Agenda - Executive Policy Committee - July 20, 2005

Report - Standing Policy Committee on Property and Development - July 18, 2005

Item No. 5 Amendment to the Approval of DASZ 12/2003 (Paul Martin Drive) File DASZ 12/2003

Re: Proposed amendment to the approval of DASZ 12/03 (Paul Martin Drive) – DASZ 12/03

A copy of a sketch forming part of Council's July 21, 2004 approval is attached.

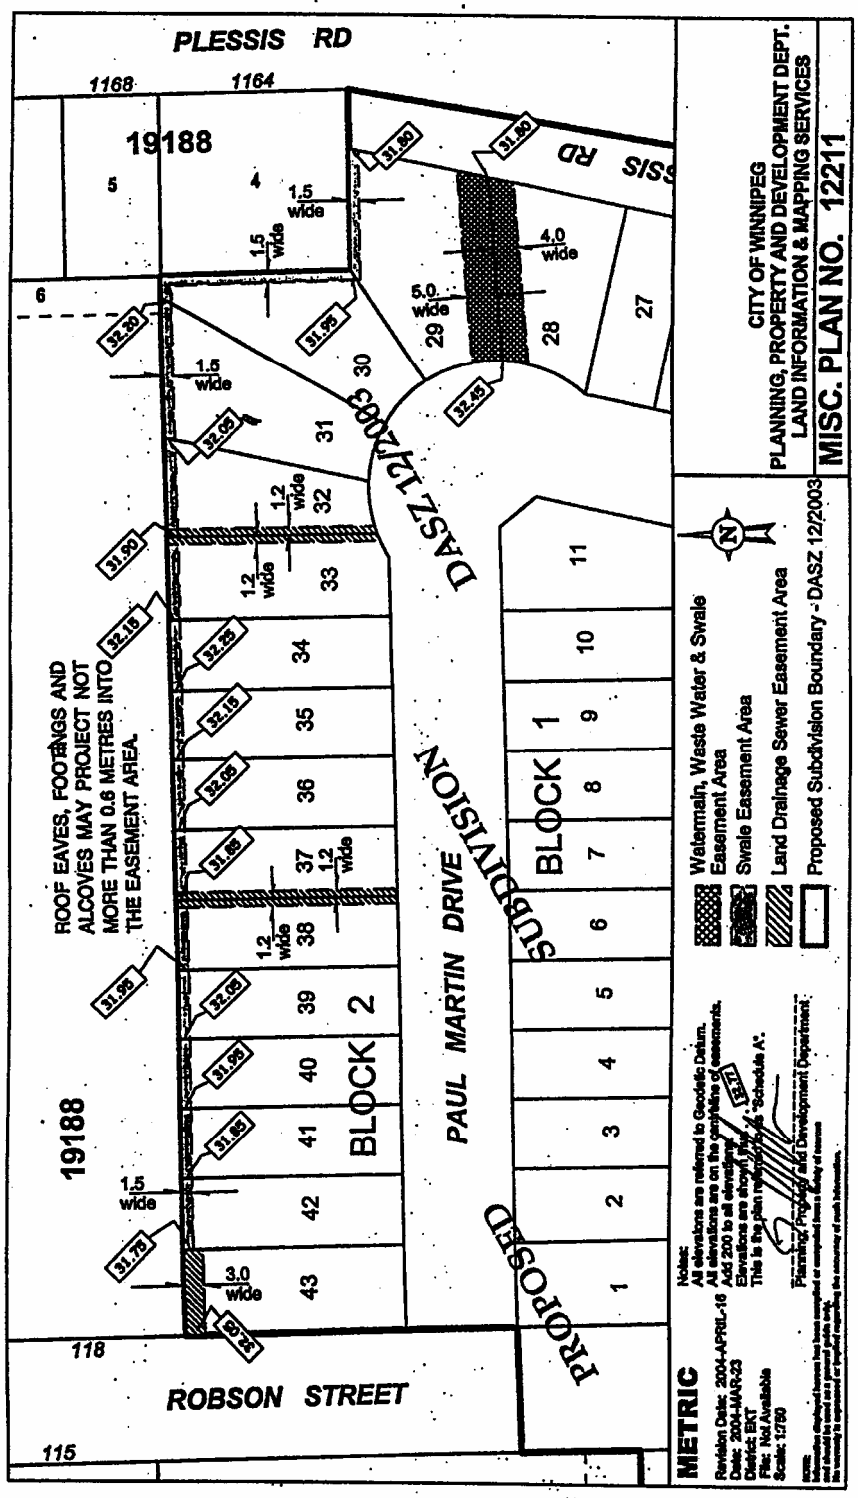
Due to an oversight by the Developer's real estate agent, Lot 29, Block 2 was sold with no provision for the agreement between the City and the Developer that a pedestrian walkway and emergency access would be established on the most southerly 5.0m of Lot 29. The balance of the walkway/access to be established across Lot 28, Block 2 is still available. The Developer, following months of negotiations with the owner of Lot 29, Block 2, was able to purchase 2.0m which would be transferred to the City resulting in a 6.0m walkway rather than the 9.0m walkway initially contemplated. The Public Works Department has assessed the situation and has determined that the 6.0m walkway could also accommodate an emergency vehicular access as this width is comparable to the width of a standard lane right-of-way.

It is therefore recommended that Council's approval of July 21, 2004 be amended by stipulating that the Developer shall transfer 6.0m to the City for the establishment of a walkway and emergency access rather than 9.0m. (All other conditions of Council's July 21, 2004 approval remain unchanged.)

1. That Development Agreement 12/2003 be further amended by stipulating that the Developer shall transfer 6.0 (six) metres to the City for the establishment of a walkway and emergency access rather than 9.0 (nine) metres.
